Our Reference: SYD19/01456/06
Council Reference: DA19/0704

PROPOSED STAGED SUBDIVISION OF LAND TO CREATE 265 RESIDENTIAL LOTS, 14 INDUSTRIAL LOTS, OPEN SPACE LOTS, 17 RESIDUE LOTS AND ROAD DEDICATION 16 CHAPMAN STREET AND 2 WATER STREET, WERRINGTON

TfNSW Operational Traffic Modelling Team Review and Comments

2 Water Street and 16 Chapman Street, Werrington. Residential and Industrial Subdivision.

Print Screen 1: This mean from two existing lanes (Stage 1) to one existing lane (Stage 1 revised layout).

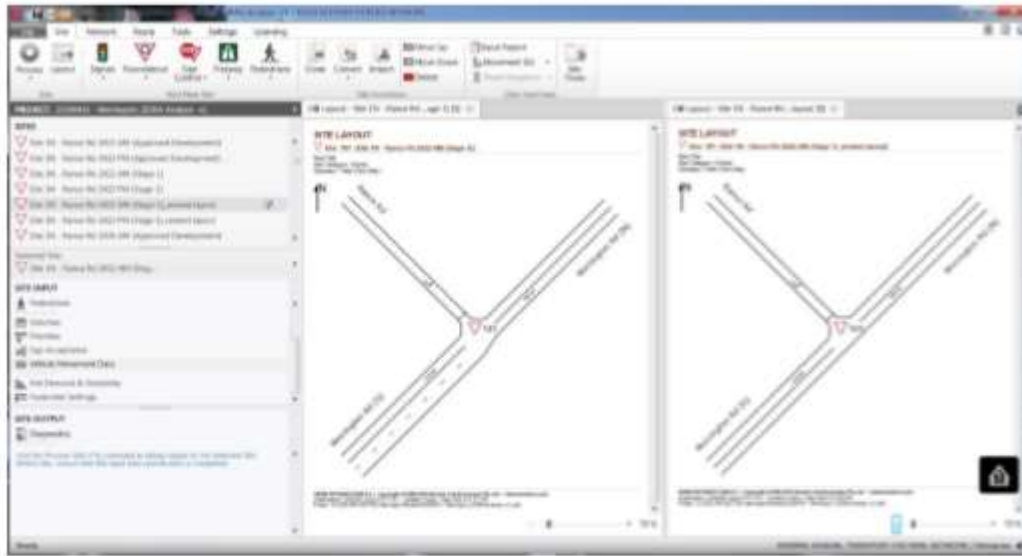
Item	Section	Comment	Priority (major, medium, or minor)
1	Site 1	Rance Rd 2020 AM&PM (Base)-outbound Rance Rd 2020 AM&PM (Base)-inbound Rance Rd 2022 AM&PM (Base)-outbound Rance Rd 2022 AM&PM (Base)-inbound Rance Rd 2030 AM&PM (Base)-outbound Rance Rd 2030 AM&PM (Base)-inbound	ok
2	Site 1N	Rance Rd 2022 AM&PM (Approved Development) Rance Rd 2022 AM&PM (Stage 1) Rance Rd 2022 AM&PM (Stage 1)_revised layout	Refer to the print screen 1
3		Rance Rd 2030 AM&PM (Approved Development) Rance Rd 2030 AM&PM (Stage 1) Rance Rd 2030 AM&PM (Stage 1 revised layout) Rance Rd 2030 AM&PM (Ultimate development _4-leg roundabout)	? Major it is not roundabout
